UNITED STATES
NUCLEAR REGULATORY COMMISSION
WASHINGTON, D. C. 20555

SAFETY EVALUATION REPORT
EVALUATION OF LPCI SWING BUS TRANSFER SCHEME
REGARDING SINGLE FAILURE VULNERABILITY
BOSTON EDISON COMPANY
PILGRIM NUCLEAR POWER STATION
DOCKET NO. 50-293

FIGURE 1

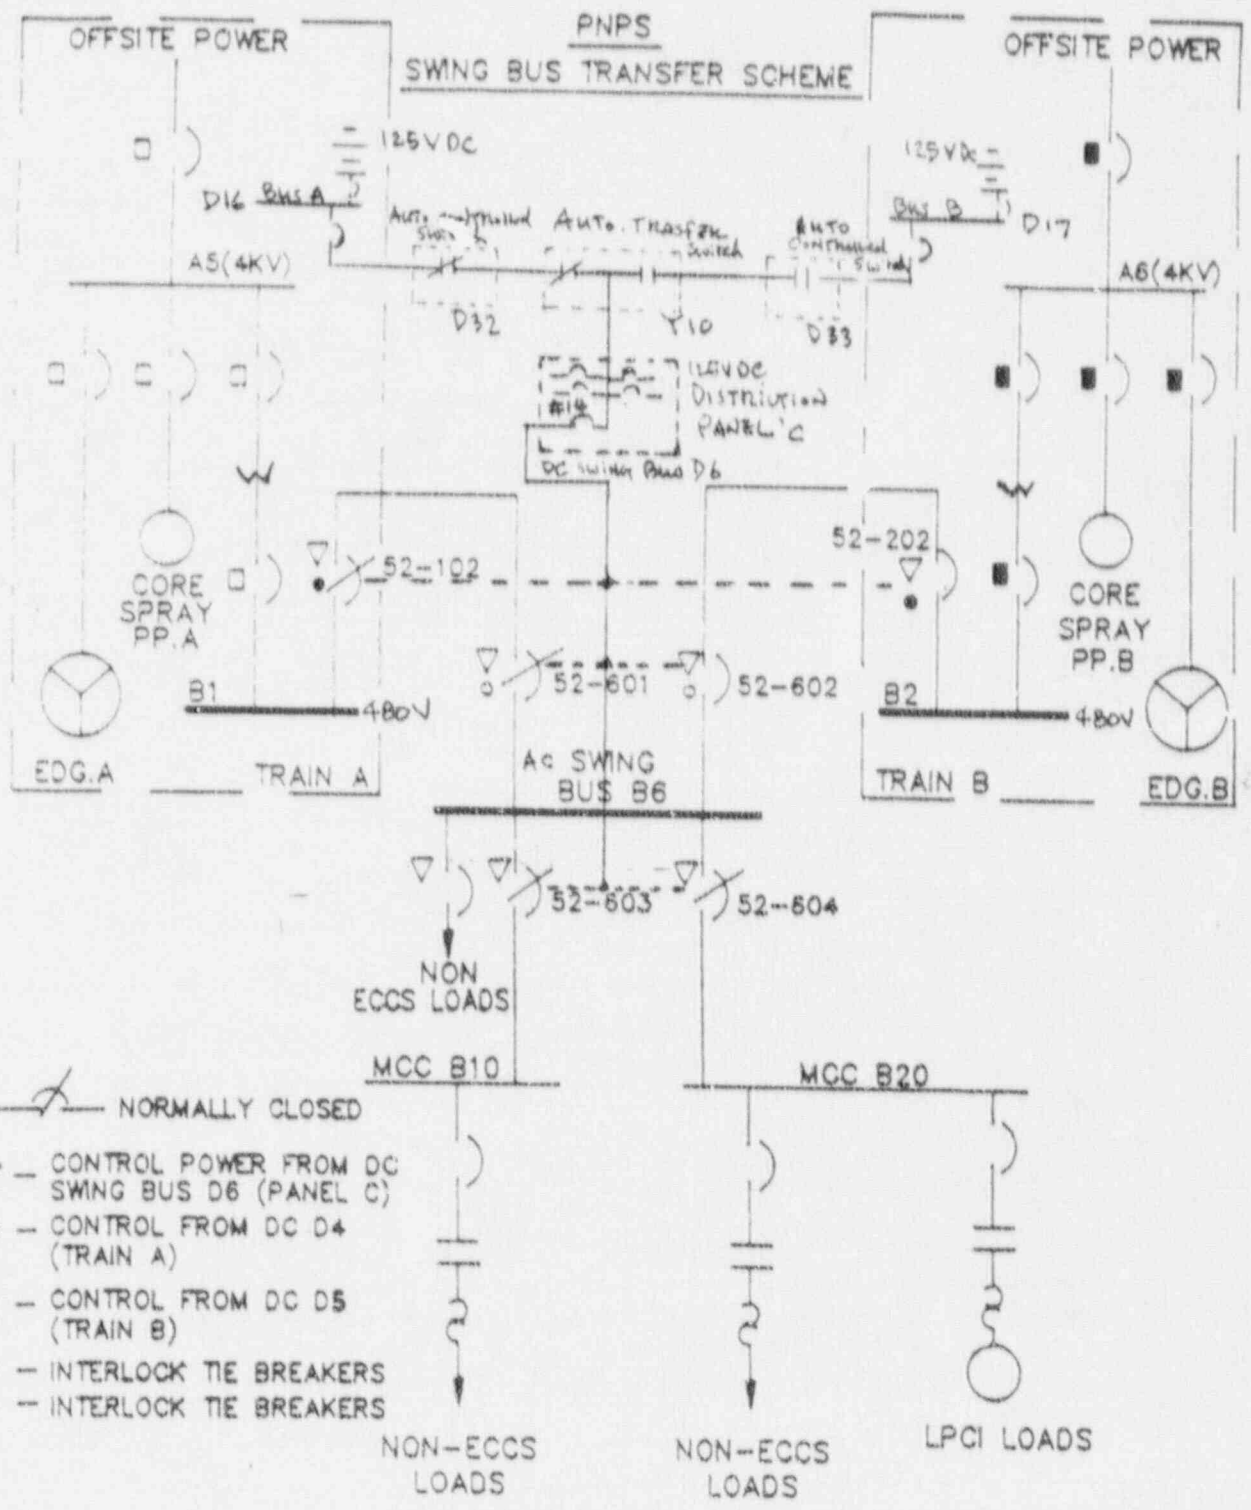
The LPCI swing bus B6 receives power from either 480v bus B1 or B2 through two series connected circuit breakers 102 and 601, or through 202 and 602 (see Figure 1). One set of breakers is closed while the other set is open. Upon a loss of normal supply voltage, an automatic transfer signal causes both closed circuit breakers to trip after a time delay and the open circuit breakers are then closed by two independent closing signals.

The control power for the breakers feeding the above ac swing bus B6 and their LPCI related load breakers is supplied from dc swing bus D6 in distribution panel C. The dc swing bus D6 receives power from the A train battery through an automatically controlled switch in panel D32 in series with the normally closed portion of an automatic transfer switch (ATS) in panel Y10. The alternate power supply to the dc swing bus D6 is from the B train battery through an automatically controlled switch in panel D33 and an ATS in panel Y10 which are normally kept open (See Figure 1.)

2. Two pairs of series connected power supply breakers are used to feed ac power to bus B6 from either the 480V B1 or B2 bus. This design differs from FERMI-2 where magnetic contactors are used. The magnetic contactors at Fermi-2 are powered from a dc bus and are normally energized to remain closed. Upon loss of dc control power, the contactors are de-energized interrupting the ac power supply to the LPCI swing bus. Although, at Pilgrim, a single breaker (No. 14) on dc bus D6 provides control power to all the breakers required for LPCI function on bus B6, a loss of dc control power to this breaker would not interrupt the power supply to bus B6 and their LPCI loads since they are normally closed and will remain closed upon loss of dc control power. Thus, during a postulated loss of dc control power event, both LPCI and two core spray pumps would be available to perform ECCS functions at Pilgrim.

3. Because the dc swing bus D6, which provides control power for all the breakers on the ac swing bus B6 can be powered from either of the two battery trains, a single dc control power failure in one train would not result in a loss of the ac swing bus B6. When undervoltage occurs in one train, (for example D16, as shown in Figure 1) the logic causes one auto controlled switch (D32) to open and send a signal for the other auto controlled switch (D33) to close. Also, the ATS in panel Y10 senses that power is now coming from D33 instead of D32, and transfers to D33 to re-energize the switch bus D6. The operating current for the transfer switch is taken from the side to which the load is being transferred. Thus, a second source of control power to operate the ac breakers would be available through the dc swing bus D6 during a postulated event similar to the Fermi-2 event.

4. All supply breakers on bus B6 are coordinated with all the LPCI load breakers such that a fault on any of those load breakers will cause the breaker to trip before any of the supply breakers. This will confine a fault on the load side of bus B6. Under the worst fault condition, it would simply isolate bus B6 by containing a fault within bus B6 (i.e., no LPCI function) while making two core spray pumps available to perform ECCS function.

Based on our review of the licensee's evaluation of their swing bus transfer scheme, we concur with the licensee's finding that there is no single failure related to a dc control power that would cause the loss of both one core spray subsystem and a total LPCI function or that could tie both trains together through their ac swing bus. Therefore, we conclude that the single failure concerns experienced at FERMI-2 are not applicable to Pilgrim.
